# Service Bulletin

Throttle Cable Inspection.

All GA8 aircraft, serial numbers 8-00-004 through 8-03-027.

I/we have incorporated Service Bulletin SB-GA8-2003-07 for the above aircraft.

Figure 1

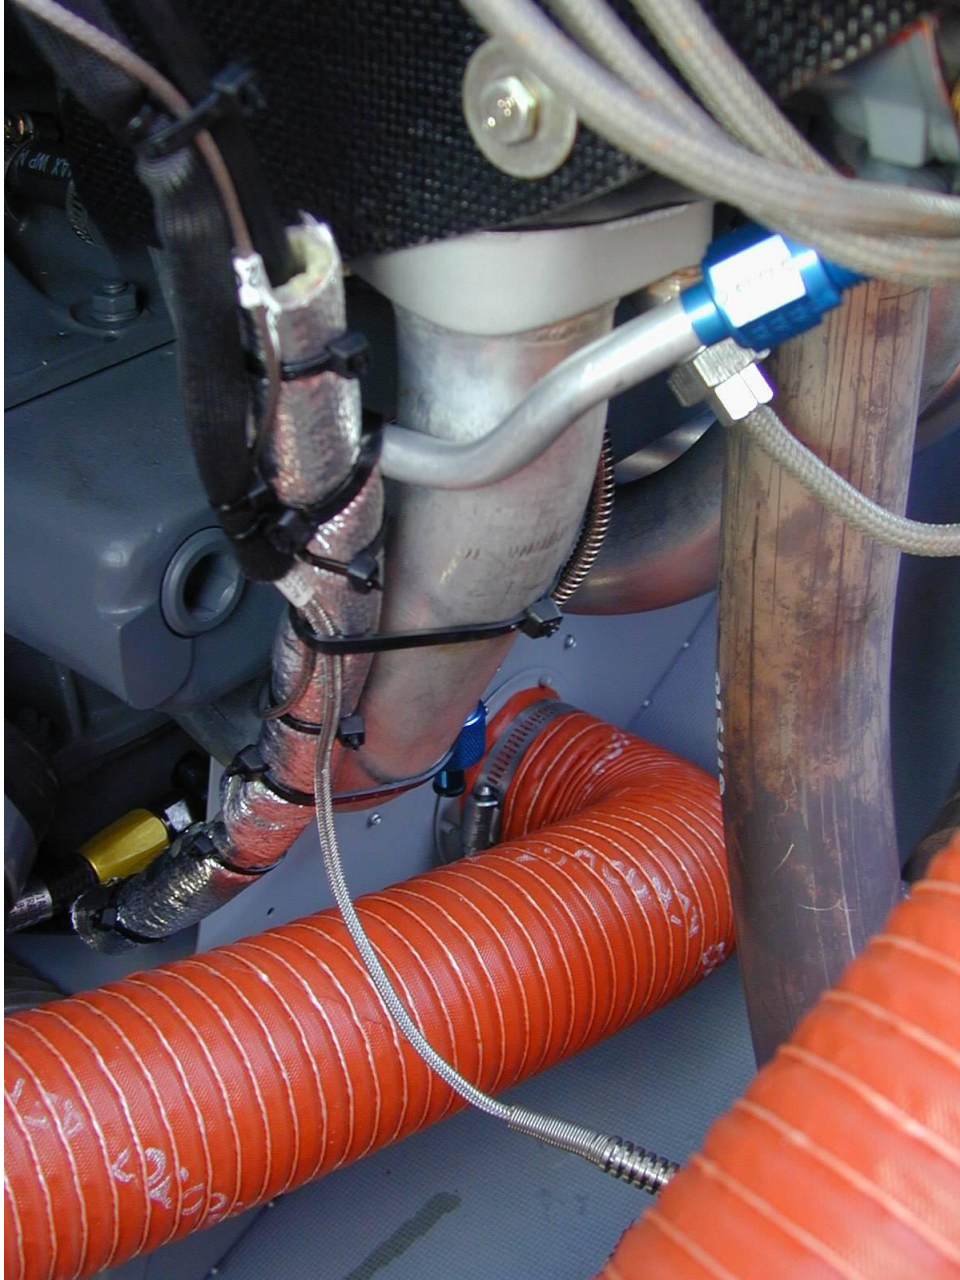
1. Remove right hand engine cowl door.
2. Cut tie wrap holding the throttle cable to engine cylinder No.5 inlet manifold.
3. Slide heat shield material along throttle cable until able to inspect the portion of normally covered cable. If the throttle cable outer sheave has deteriorated in any way, replace cable and Heat Shield Material before further flight [Order Gippsland Aeronautics P/N – GA8-761012-15 (Throttle Cable) and GA8-761022-21 (Heat Shield Material)].
4. Slide Heat Shield Material back in place adjacent to engine cylinder No.5 inlet manifold. Wrap supplied cloth (Item 1 - Throttle Cable Heat Reflective Cloth) around new or existing Heat Shield Material and tie wrap in place as shown below in Figure 1. **Ensure cable is secured to the aft side of the inlet manifold tube.**

Heat reflective cloth now wrapped around the outside of Heat Shield Material.
